| | | Table 1: Proposed Amendments to Mesa del Sol Level B Plan | | |

Mesa del Sol Level B Framework Plan Amendment July 2021

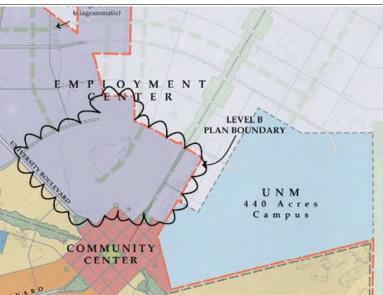
| | | Table 1: Proposed Amendments to Mesa del Sol Level B Plan | | |
|-----------------|---|---|--|--|
| 6 | Add the following: "Mesa del Sol Level B Community Master Plan and its relationship to the City's Integrated Development Ordinance On May 18, 2018, the City Council adopted the Integrated Development Ordinance (IDO). Under this new ordinance, the Mesa del Sol Level B Master Plan became what the IDO refers to as a "Framework Plan", the plan required for the creation of a Planned Community (PC) zone district. This designation of a Framework Plan does not change the way the standards and procedures that were part of the adopted Level A and Level B Master Plans. As the IDO states on page 6, Section 1-10(A)(2): For former Special Use zones that were converted to the Planned Development (PD) or Planned Community (PC) zone districts through adoption of this IDO, any approval associated with the Special Use zone is considered the required Site Plan – EPC or Framework Plan, respectively. Any use standards or development standards associated with pre-IDO approvals or zoning designations establish The rights and limitations for the PD and PC zone districts. These prior approvals are linked to development agreements between the City and the master developer, as well as the establishment of the Tax Increment Development District for Mesa del Sol. Due to the contractual nature of these agreements and their reliance upon the adopted Mesa del Sol Level B Plan, it is critical that this document continues to be referred to by its original name, while recognizing that it is also a "Framework Plan" within the lexicon of the City's IDO. Where the Mesa del Sol Level B Plan is silent on particular standards or where it refers back to City standards, then current IDO standards will apply. Otherwise, the standards and review processes and the MdS Level B Plan as approved continues to be the regulating document for parcels that fall within the Level B boundary". | NOT APPLICABLE | | |

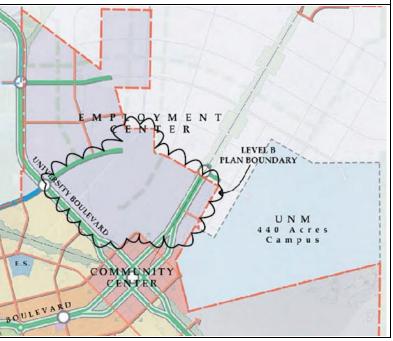
| | | | Table 1: Proposed Amendments to Mesa del Sol Level B Plan |
|--------|-----------|---|--|
| 3-1 | 47 | Updated Auto and Transit Circulation Build-Out network by removing major roadways within project boundary. Added note stating the exhibit was "revised July 2021 - modifications to roadways and linear parks/drainage corridors within southern area of Employment Center". | LOS TICAROS NATO LOS TICAROS NATO JOURNAL JOU |

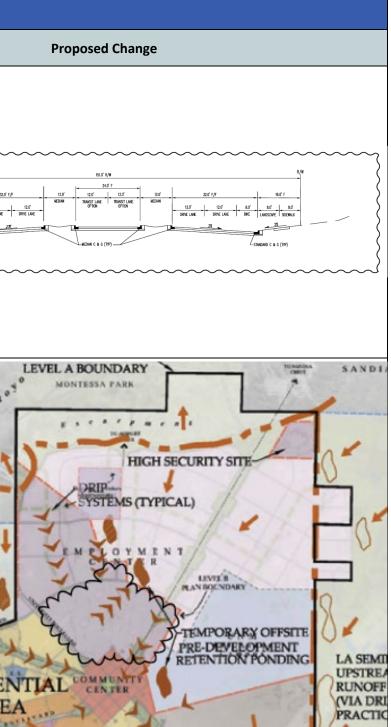
| | | | Table 2: Proposed Amendments to Mesa del Sol Level B Plan Technical Ap | pendices |
|--------|-----------|--|--|---|
| 4A-1 | 95 | Update Overall Stormwater Plan with revised approach for project area including removing/re-routing DRIP system and ID pond location(s) Added note stating the exhibit was "Revised July 2021 - modifications to utility infrastructure within southern area of Employment Center." | Montessa Park | TIJE TO AND TIJE TO AND RETENTION POND COUNTYREC COMPLEX RESIDEN |
